CITY PLAN COMMISSION**THURSDAY, JULY 23, 2026****FILE NUMBER:** PLAT-26-000157**SENIOR PLANNER:** Sharmila Shrestha**LOCATION:** Davilla Drive at Lakemont Drive, northwest corner**DATE FILED:** June 24, 2026**ZONING:** R-10(A)**CITY COUNCIL DISTRICT:** 13**SIZE OF REQUEST:** 0.245-acres**APPLICANT/OWNER:** James Poulin

REQUEST: An application to replat a 0.245-acre tract of land containing all of Lot 15 in City Block 9/6176, to create one lot and reduce a portion of the 15-foot platted building line along the west line of Lakemont Drive, varying from 7.8 feet to 13.6 feet, on property located on Davilla Drive at Lakemont Drive, northwest corner.

PRELIMINARY REPLAY
POLLIN DAVILA
LOT 15A, BLOCK 961776
BEING A REPLAY OF LOT 15, BLOCK 961776
DAVILLA DRIVE ESTATES ADDITION
FRANCIS A WINN SURETY
ABSTRACT NO. 1578
CITY OF DALLAS, DALLAS COUNTY, TEXAS
PLAT: 26-000157
DP#

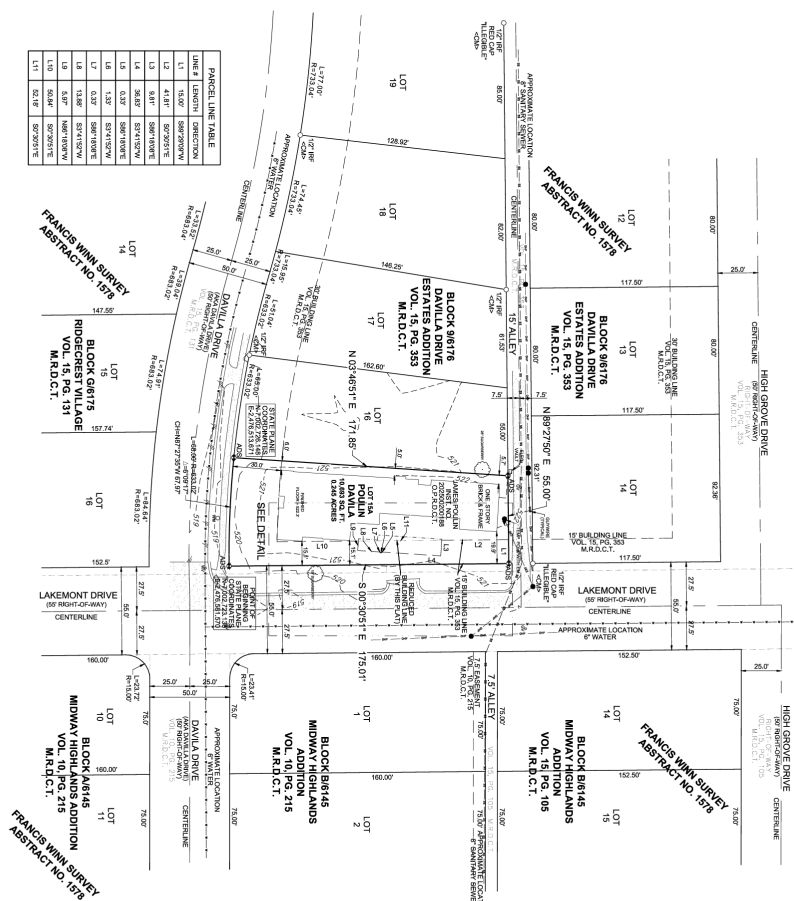
STAFF RECOMMENDATION ON BUILDING LINE REDUCTION: The request is to reduce a portion of the 15-foot platted building line along the west line of Lakemont Drive, varying from 7.8 feet to 13.6 feet. Staff finds that the request complies with the requirements of Section 51A-8.505 of the Dallas Development Code; therefore, staff recommends approval of the reduction of the portion of 15-foot platted building line along the west line of Lakemont Drive.

14. On the final plat, dedicate 28 feet of right-of-way (via fee simple or street easement) from the established center line of Lakefront Drive. Sections 51A 8.602(c); 51A 8.604(c).
15. On the final plat, dedicate a minimum 5-foot by 5-foot corner clip (via fee simple or street easement) at Lakemont Drive and Davilla Drive. Section 51A 8.602(d)(1).
16. Dedicate 15-foot by 15-foot alley sight easement at the alley and Lakemont Drive. Section 51A 8.602(e).
17. A larger corner clip may be requested during engineering plan and traffic review to accommodate an adequate turning radius, or to maintain public/traffic appurtenances, within the area of the corner clip. 51A 8.602(d)(1), 51A 8.608(a).

22. On the final plat, change "Davilla Drive (AKA Davila Drive)" to "Davilla Drive."
23. On the final plat, change "High Grove Drive" to "Highgrove Drive."
24. On the final plat, identify the property as Lot 15A in City Block 9/6176.
